Number	Description
1	Revised Table of Contents; Added NTB No. 3836; NTB No. 4638 replaces NTB No. 6; Revised Bid Items; Revised or Added Plan Sheet Nos. 8001-8002, 8008, 8017, 8022, 8024, 8033, 8039, 8055, 8060, 8071, 8076 & 8083; Amendment EBSx Download Required.
2	Revised or Added Plan Sheet Nos. 8001, 8003, 8019, 8035, 8057 & 8073; Amendment EBSx Download Required.

The following is my (our) itemized proposal.
STBG-2712-00(003)/ 106101301000
Leflore County(ies)

ADDENDUM

MISSISSIPPI DEPARTMENT OF TRANSPORTATION
DETAILED INDEX
(BRIDGE)
FMS: 106101 / 301000
COUNTY: LEFLORE
PROJECT NUMBER: STBG-2712-00(003)
DESIGNER: Jason Blakely
CHECKER: Stephen Diaz
DATE: 10/10/2024
ISSUE DATE: 2024-10-10
DETAILER: Jason Blakely
STATE: MISSISSIPPI
PROJECT NUMBER: STBG-2712-00(003)
WORKING NUMBER: 01-BR-1
SHEET NUMBER: 8001
REP. DIR. OF TRANSPORTATION, 3851 STATE BRIDGE ENGINEER - SOUTH WESTFIELD, P.E.

MISSISSIPPI DEPARTMENT OF TRANSPORTATION
BRIDGE AT STA. 28+03.92
SR 442 OVER PECAN BAYOU (US)
GENERAL NOTES &
ESTIMATED QUANTITIES
FMS: 106101 / 301000
COUNTY: LEFLORE
PROJECT NUMBER: STBG-2712-00(003)
WORKING NUMBER
A1 OF A16
SHEET NUMBER
8003

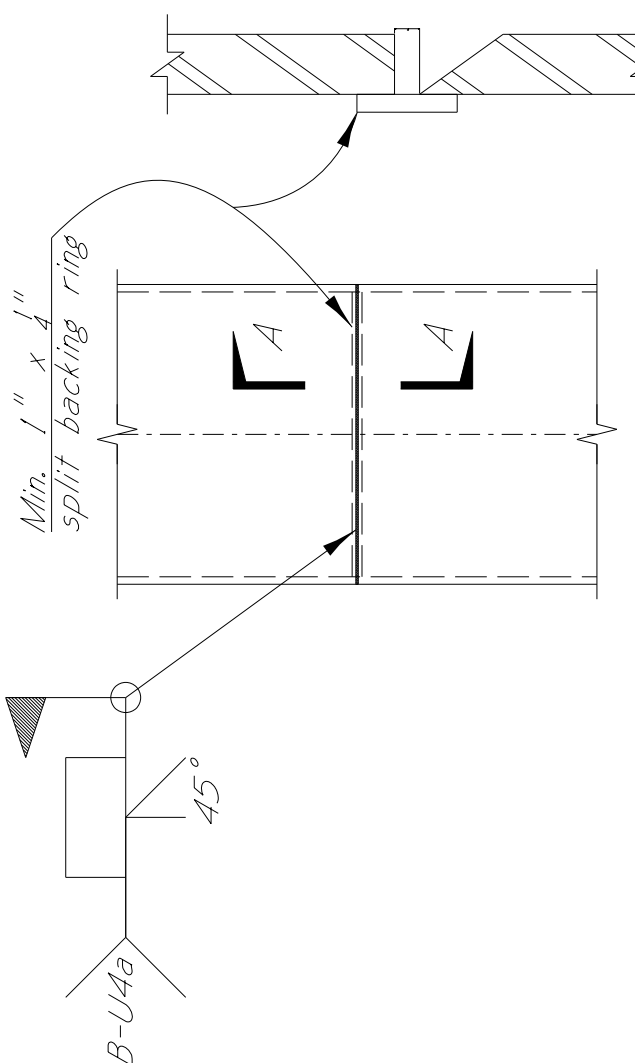
Item	Trans. Grooving	Conventional Static Pile Load Test	PDA Test Steel Pile	Pile Restrike	18" Steel Piling Wall Thickness 0.375"	24" Steel Piling Wall Thickness 0.500"	Bridge Concrete Class AA	Concrete Class BDX	56 Ft. Prest. Conc. Beams MB-25	85 Ft. Prest. Conc. Beams FB-36	Reinforce-ment Lb.	Reinforce-ment Corrosion Resistant Lb.	Concrete Rebar, 36	Loose Riprap (300#)	Geotextile Under Riprap	Preformed Joint Seal	
Location	S.Y.	Each	Each	Each	L.F.	L.F.	C.Y.	C.Y.	L.F.	L.F.	Lb.	Lb.	L.F.	Ton	S.Y.	L.F.	
Spans	701.04	-	-	-	-	-	-	213.06	869.33	420.83	51,113	2,632	394.33	-	-	-	
End bents	-	-	1	1	1265	-	58.30	-	-	-	70,734	-	-	-	-	-	
Int. bents	-	1	1	1	-	-	67.95	-	-	-	9,858	-	-	-	-	-	
Totals	701.04	1	2	2	1265	675	126.25	213.06	869.33	420.83	71,705	2,632	394.33	1,612	1,290	1,290	73

WORKING NUMBER
C1 OF C22
SHEET NUMBER
8035

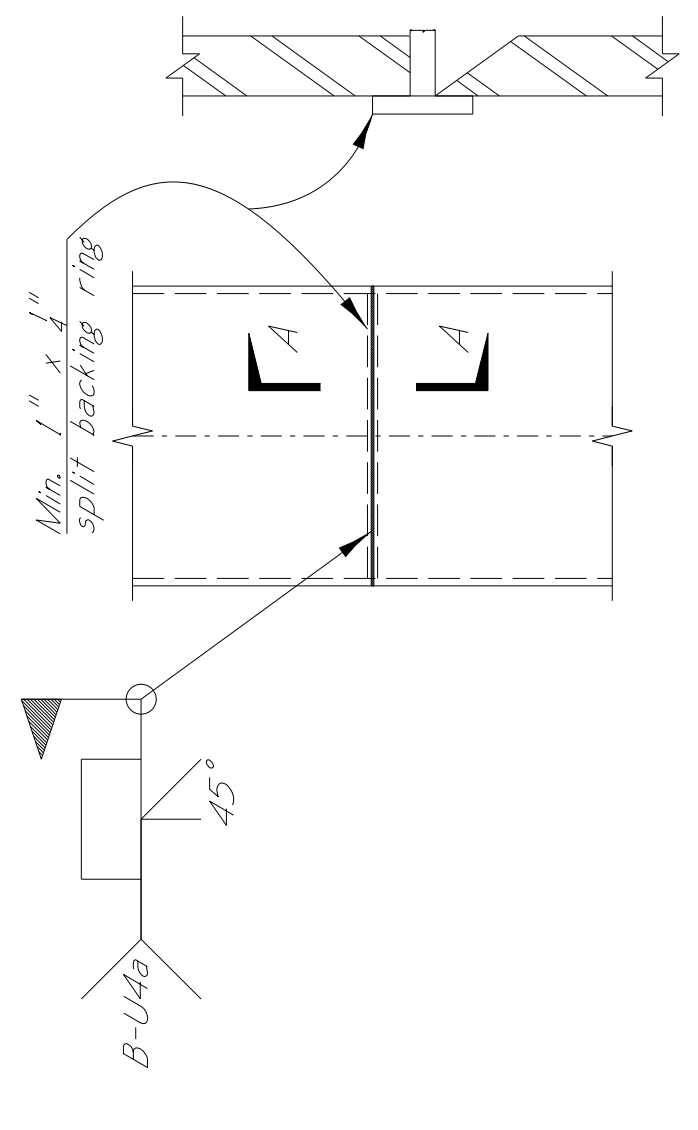
REVISION
Revised File Notes

MISSISSIPPI DEPARTMENT OF TRANSPORTATION
 BRIDGE AT STA. 214+38.92
 SR 442 OVER MCNUTT LAKE
 GENERAL NOTES &
 ESTIMATED QUANTITIES
 FMS: 106101 / 301000
 COUNTY: LEFLORE
 PROJECT NUMBER: STBG-2712-00(003)
 WORKING NUMBER
 DI OF D16
 SHEET NUMBER
 8057

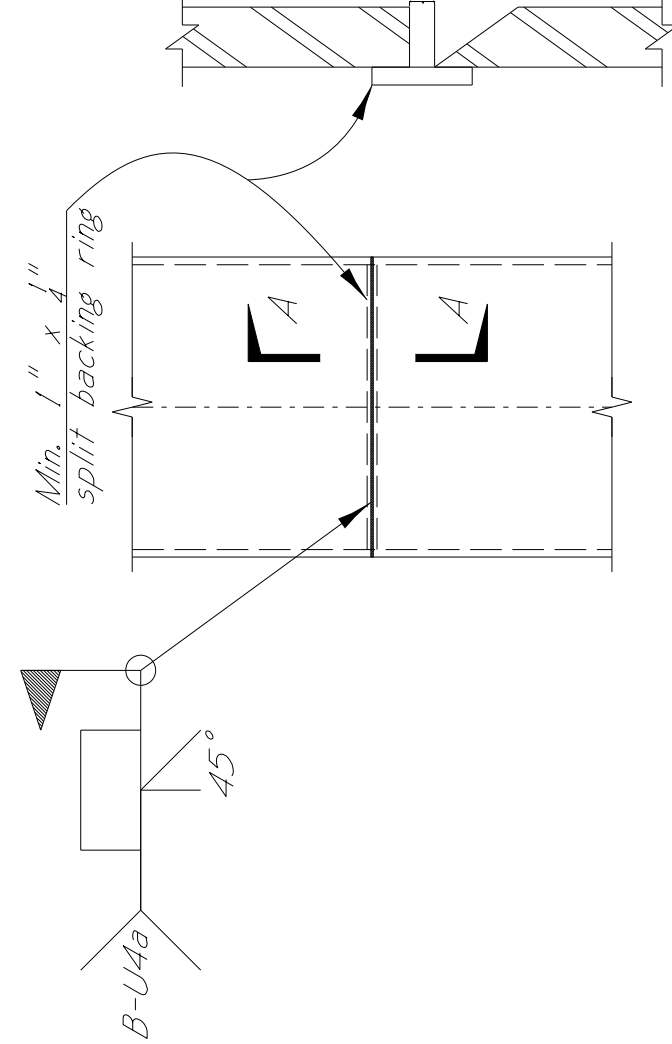
DATE	REVISION	BY
10/19/22	Revised Pile Notes	SM

DESIGNER: Shana Wright
 DETAILER: Shana Wright
 CHECKER: Shana Wright
 DATE: 10/19/22
 PROJECT NUMBER: STBG-2712-00(003)
 COUNTY: LEFLORE
 FMS: 106101 / 301000
 WORKING NUMBER: E1 OF E12
 SHEET NUMBER: 8073

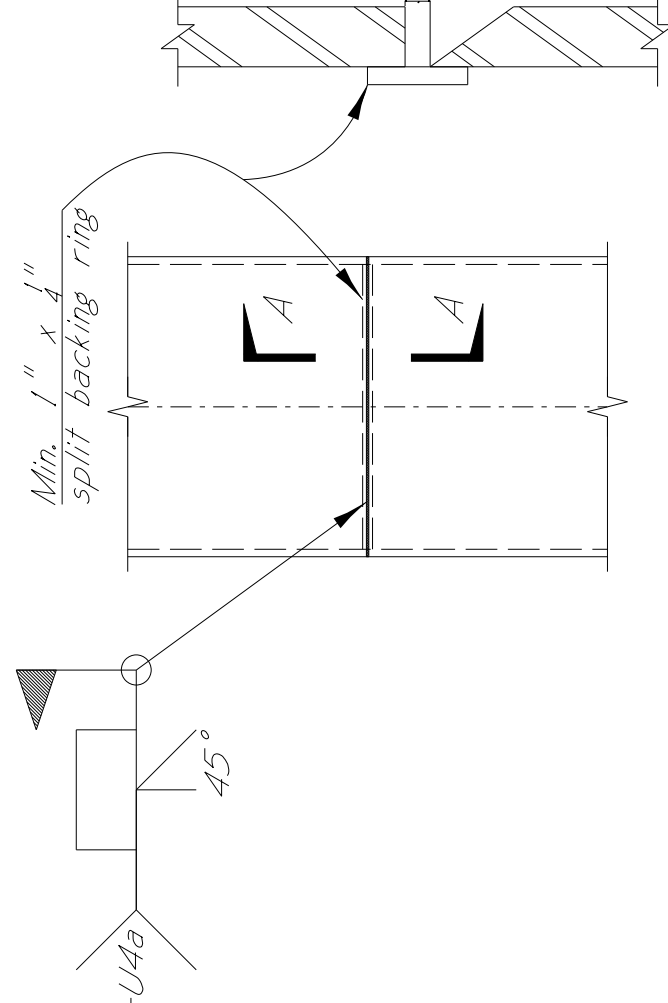
REVISION
 Revised File Notes
